Meeting Agenda

Project 2014-01 Standards Applicability for Dispersed Generation Resources Standards Drafting Team

DGR SDT SAR Comment Responses

Figure I2-5: Multiple Unit Generating Site (BES)

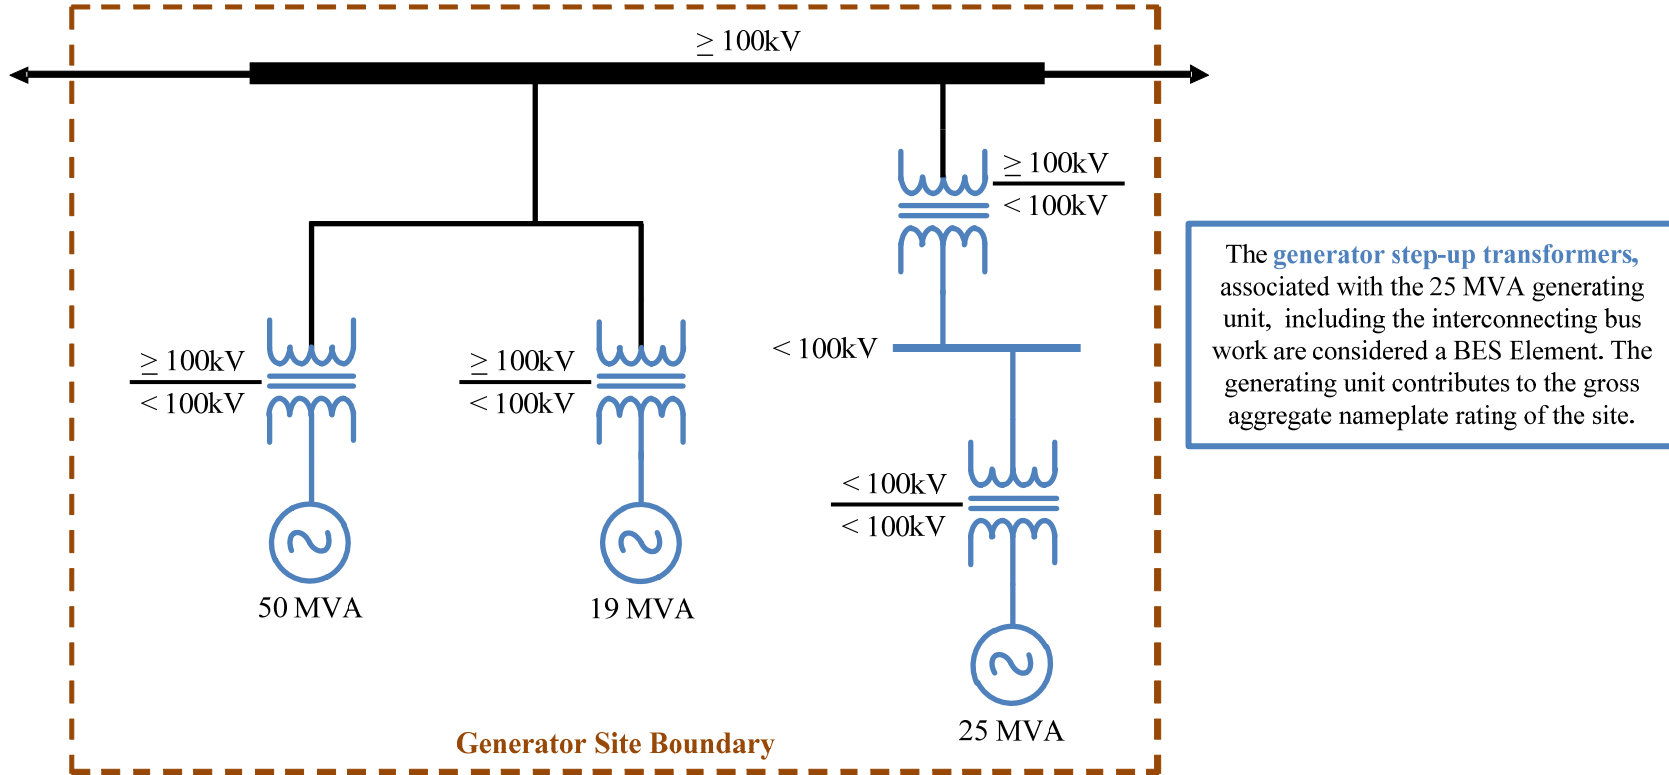
(1) Apply the Generator Site Boundary used in the BES Definition Reference (e.g. Figure I2-5) consistently for dispersed generation so that multiple GSU do not circumvent the 75MVA aggregate. (2) Develop a NERC Glossary definition for the term 'dispersed generation'. Ameren.
